To: Development Determination Panel
Cc: Rodney Piggott
From: Luke Zajac (Consultant Planner - Mecone)
Date: 4 November 2022
Subject: Supplementary Assessment Report
Record Number: DA2022/0033

SUPPLEMENTARY ASSESSMENT REPORT

Extract of lower ground floor plan

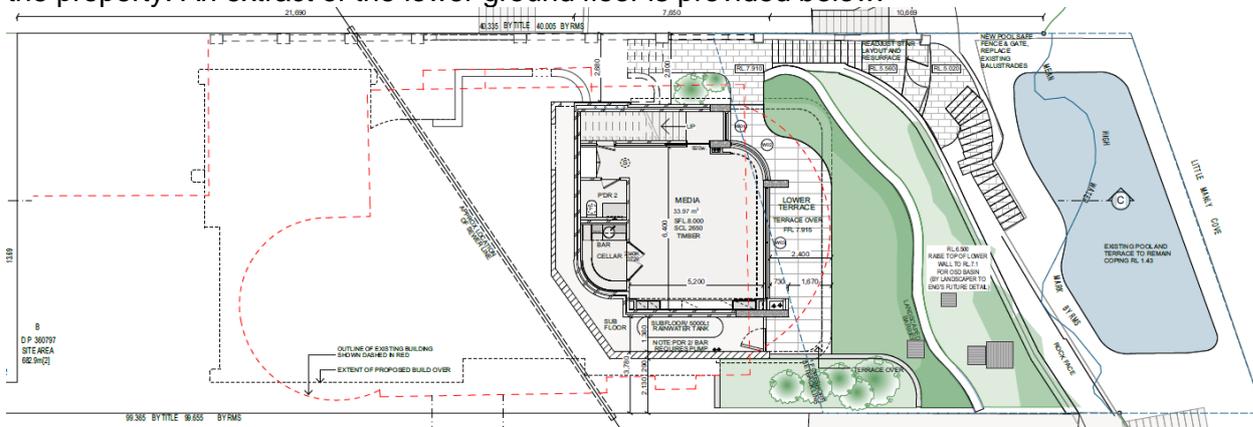
The proposal provides a part 2, part 3 storey dwelling. The third-storey element occurs as the first floor extends over a partial basement/lower ground floor towards the rear of the property. An extract of the lower ground floor is provided below.

The third storey element is a result of the slope of the site and existing cut present. The existing cut to the eastern portion of the site is suited for a lower ground/partial basement level and represents an appropriate design outcome that responds to the topography of

the site. Whilst the third storey element results in a breaching height limit, the breach is limited to non-habitable building elements including the pitched roof structure, an awning over a balcony and rooftop terrace and associated balustrades. As demonstrated by the applicant in their Clause 4.6 request, the breach does not result in any adverse impacts and is a result of the sloping nature of the site.

Extract of roof plan with existing building envelope overlain.

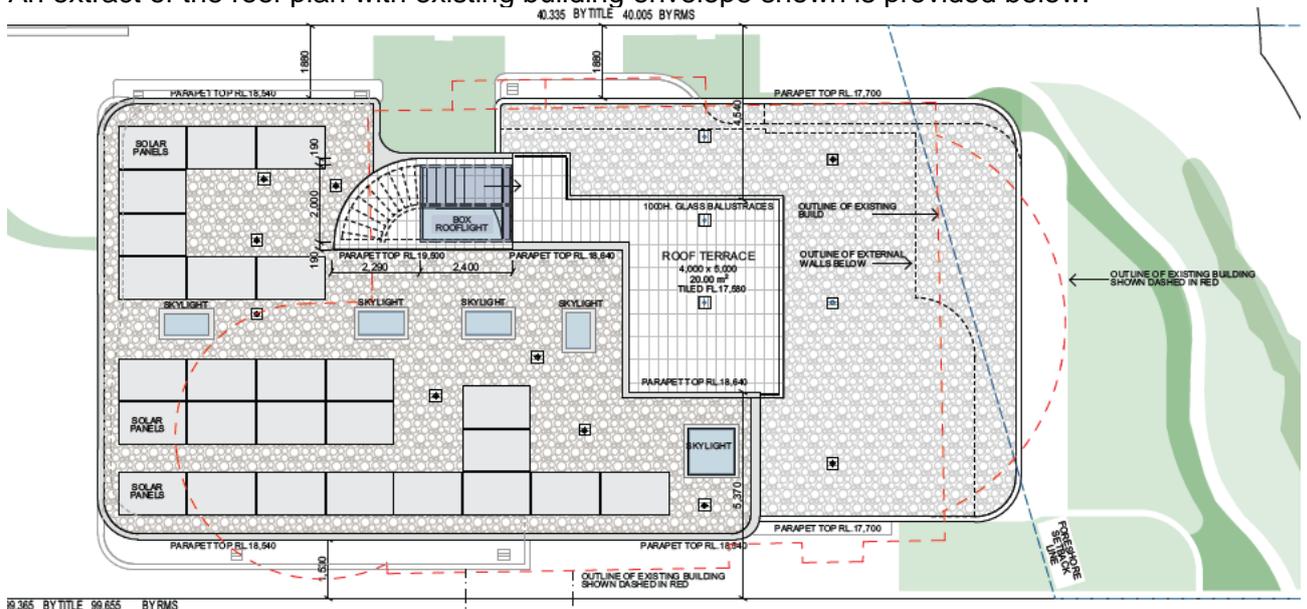
It should be noted that the proposal will increase the side setbacks compared to the existing development on the site, including an increase from 0.6m to 1.2m on the western boundary, and 2m to 2.8m on the eastern boundary.

Response: The proposed side setbacks are found to be an improvement from the existing development in the above objectives of privacy, view sharing, adequate space between buildings, equitable access to light, sunshine and air movement as the setback has been increased.

The staggered side setbacks to the western elevation provide for an articulated built form that provides usable private open space in the side setback. The elements setback beyond the specified wall height calculation offset the breaching elements, providing relief and visual interest to the adjoining site.

The building envelope resolves the minimal setback issues present between the site to the east, almost doubling the setback on the first floor.
